**Re: Harmony Point on the Magothy
Lot 17, Block M
Variance Application**

SHEET 1 OF 1
VARIANCE PLAN

HARMONY POINT ON THE MAGOTHY
LOT 17, BLOCK M

CONFIRMATION OF PRE-FILE

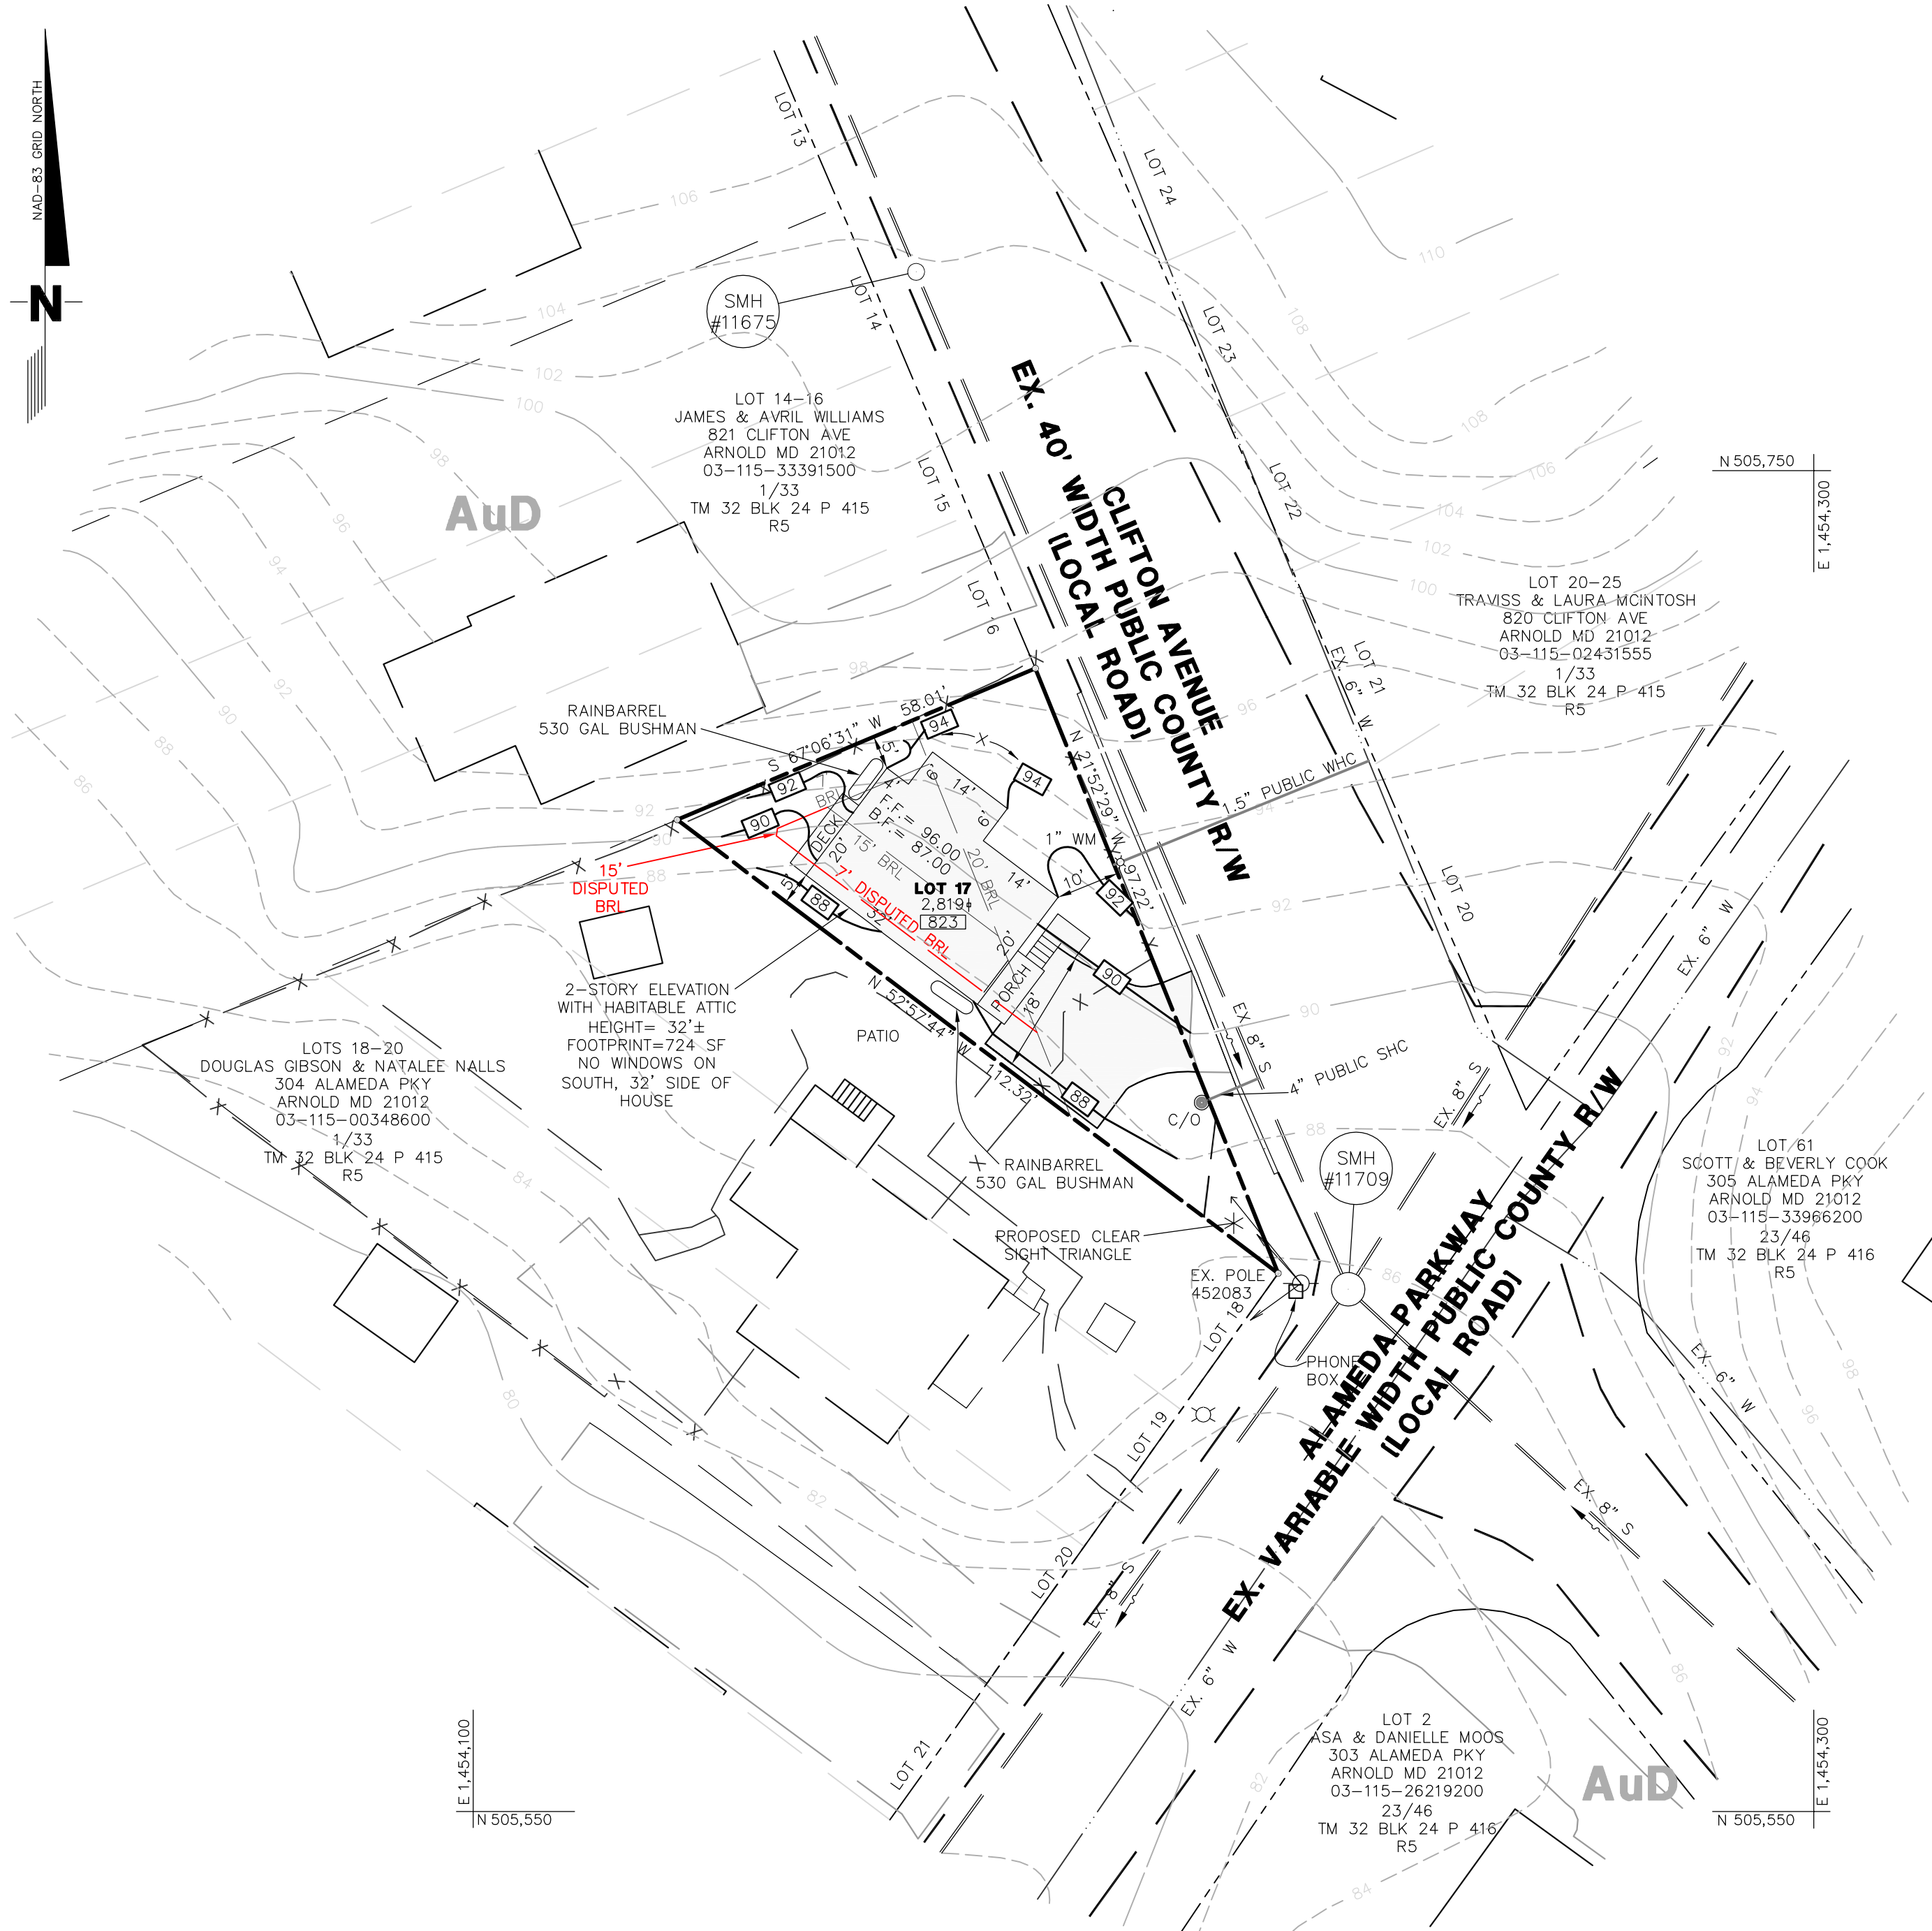
1. On the Variance Site Plan, show the location of the proposed water meter and the sewer cleanout.
2. On the Variance Site Plan, demonstrate this lot has adequate area to discharge water from the two 530 gallon rainbarrels.
3. The driveway must enter the road perpendicularly, per County Details.
4. Show the proposed grading for this lot.
5. On the Variance Site Plan, if an item has a symbol shown on the legend, it should also be shown on the Plan View. Otherwise, it should be removed from the legend.
6. Per DPW's Design Manual, "no driveway shall be located within 50 feet from the P.C. of the intersection curb radius." The supposed existing driveway apron is substandard and appears to be leftover pavement rather than a proper county driveway entrance.

1. The site plan shows a 15' side setback as of July 1, 2025. This distance should be 7' for a side lot line.
2. The common lot line between 823 Clifton Ave and 304 Alameda Pkwy is a rear lot line. Currently the setback is 20' and as of July 1, 2025 the setback will be 15 feet. The short side of the triangle is a side. Adjust the site plan and letter accordingly. See below:
